Date: 1 October 2025

RE: Torfichen Wind Farm

Torfichen Wind Farm - 15 Turbine Layout Revised BNG Assessment

FIGURE 1

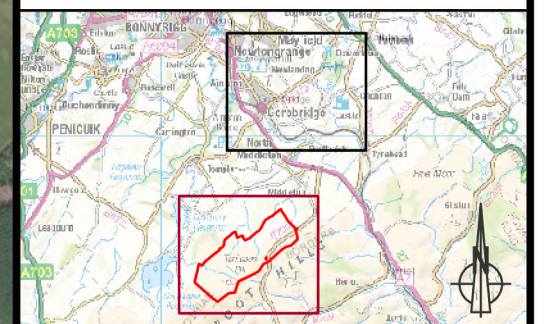
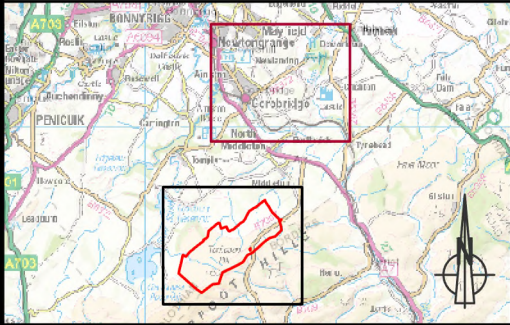
The alternative 15 Turbine layout, if progressed, would require the removal of proposed OBEMP areas C1 and C2, with only area C3 being taken forward for bracken control (see revised Figure 1 attached). All other areas and proposals relating to OBEMP areas A, B, D and E remain as per the FEI OBEMP.
